**Docket No. LC 68**

IDAHO POWER COMPANY,

2017 Integrated Resource Plan

Staff's Opening Comments

**Figure 2 – Comparison of Total Annual Savings to IRP Targets**

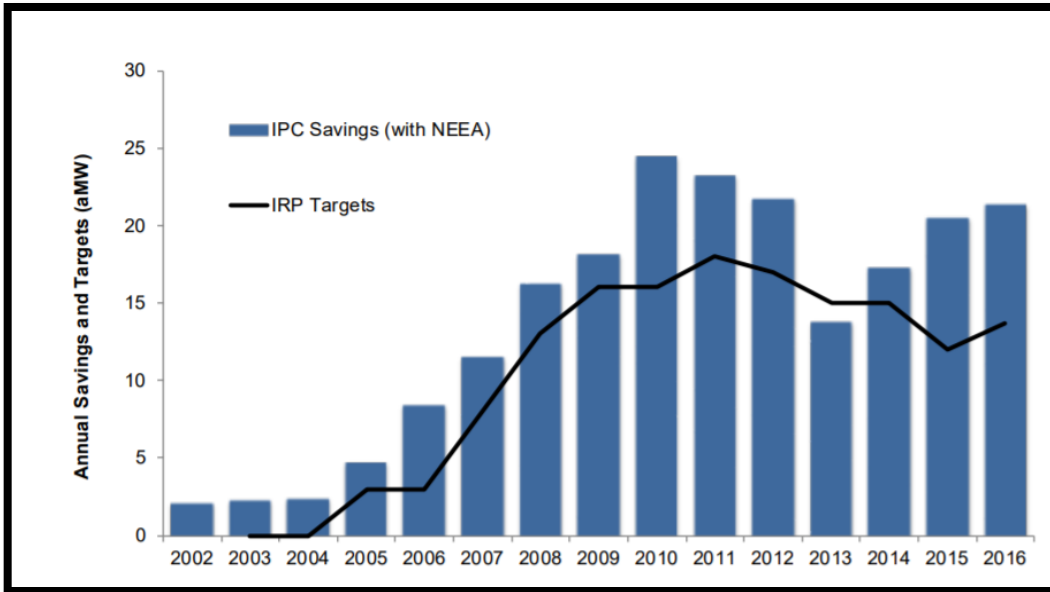
In 2016, efficiency savings exceeded the Company’s IRP savings target by 30 percent and grew 4 percent over 2015.<sup>40</sup> In 2015, Idaho Power’s EE savings exceeded its IRP target by 55 percent.<sup>41</sup>

However, the Company projects an approximately 10 percent reduction in cumulative EE savings over the 20 year planning horizon in the 2017 IRP as compared to the 2015 IRP.<sup>42</sup> *Figure 2* captures the extent of the difference on an annual basis. Notably, most of the efficiency decline in this IRP happens early in the 20 year time period of the IRP analysis.

**Figure 3 – Annual Percent Difference Between 2015 and 2017 IRP Savings**

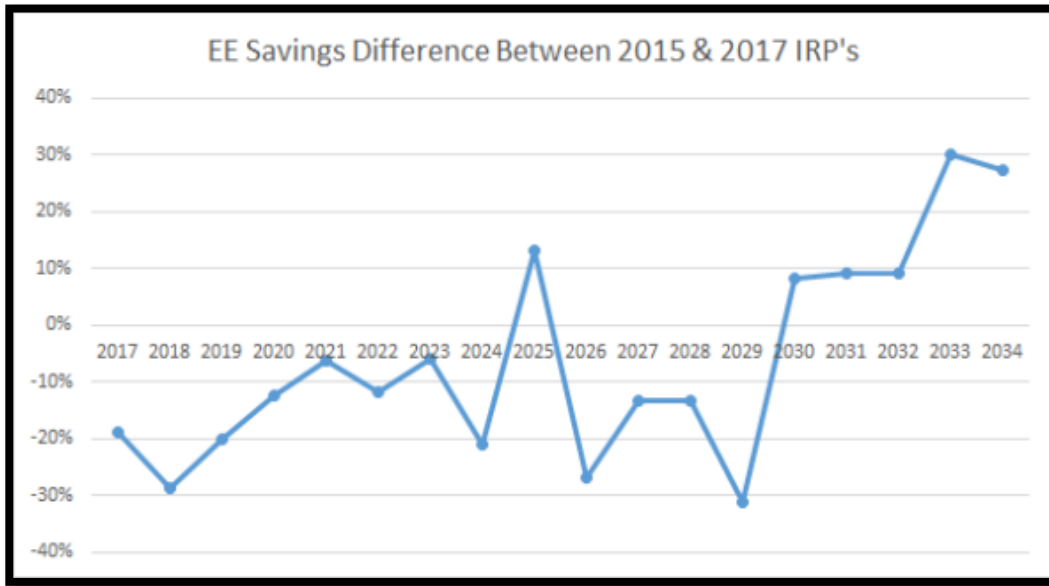
The IRP is unclear about the reasons for the substantial, near-term decline in EE savings. Staff has concerns about the Company's residential EE forecast. As shown in Figure 3 above, the immediate drop in residential EE is troubling, especially given its contribution to peak-load reduction. Again, Staff understands there are several pressures on residential savings but believes a more in-depth explanation is warranted for the 2017 IRP. For example, the Company has not clearly demonstrated how much of the large forecasted decline in the annual residential savings from 2017 through 2021 is due to changes in the lighting market or some other factor. To this end, the Company should more clearly identify ramp rates around key technologies like heat pumps and how these assumptions changed between the 2015 and 2017 IRPs.

**Figure 4 – Residential Savings Forecast Difference, 2015 and 2017 IRPs**

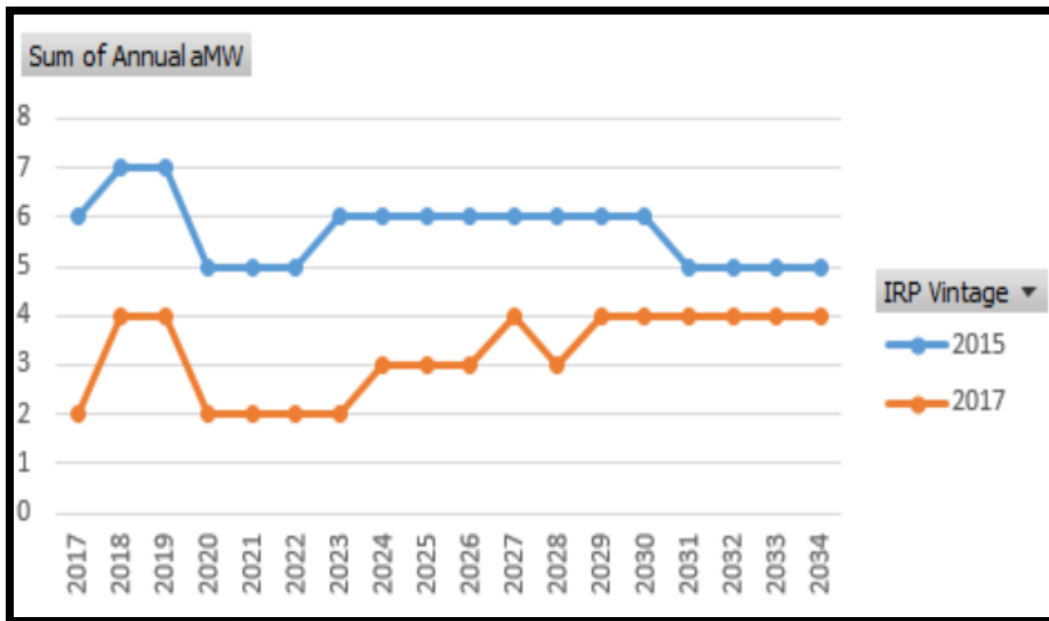
The reduction in annual savings targets between the 2015 and 2017 IRPs is most pronounced for the residential sector. As can be seen in Figure 3, the EE IRP targets drop over 50 percent during the 2017 IRP action plan time horizon and in the years leading up to the completion of B2H.

Staff understands that there are several pressures on residential savings over time—for example, Federal Standards on lighting, improving building codes, and lower avoided

**Figure 5 – Henry Hub Natural Gas Spot Price** <sup>52</sup>

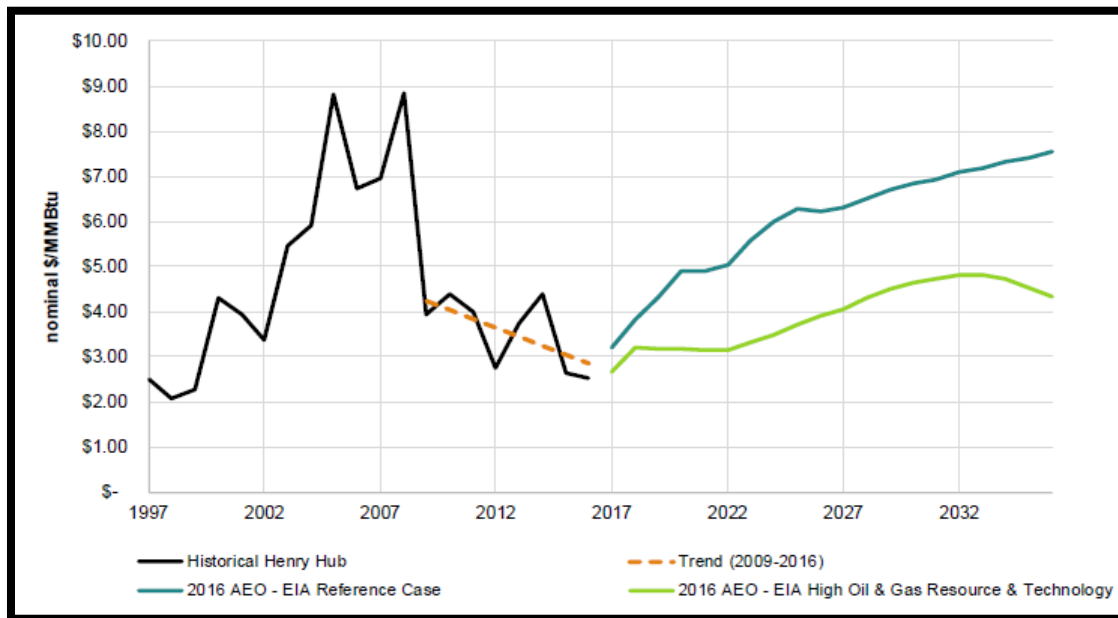
case by 50 percent (green line). The green line is EIA’s High Oil & Gas Resource & Technology (EIAHO) case, which Idaho Power uses as its own planning case.

Idaho Power elects to use the low-price case instead of the reference case as its base case for modeling and analysis of resources

Idaho Power tested various sensitivities<sup>53</sup> and applied stochastic shocks<sup>54</sup> to its gas price analysis to determine a range of outcomes as a result of changing prices. However, Idaho Power’s planning case is lower than any of the sensitivities,<sup>55</sup> and most of the stochastic shocks trended above this planning case. This indicates that Idaho Power is largely analyzing upward price risk, and in the case of modeling sensitivities, prices lower than the planning case are not considered at all. When Staff asked why the Company chose a low planning case, Idaho Power stated that “actual natural gas prices have consistently been lower than the Idaho Power IRP Planning Case EIA forecast selected in the past several IRP cycles.”<sup>56</sup> In addition, Idaho Power reviewed settled forward contracts through the intercontinental exchange (ICE) and stated that the ICE forecasts were shown to be more accurate than the EIA Planning Case forecast used in the IRP over the past few years. Because the 2016 EIAHO case forecast “closely followed the ICE forward contract prices as compared to the other available EIA forecasts,” the EIAHO case forecast was selected because it “seems to be the most likely future.”<sup>57</sup>

Staff does not dispute that gas prices have been consistently trending down in the past few IRP cycles. However, Staff does believe that Idaho Power seems to have used subjective judgment in determining what a likely future was. The Company seems to have utilized a short-term ICE forecast to inform the decision to use the EIAHO projection and as a result based its planning case on that future.
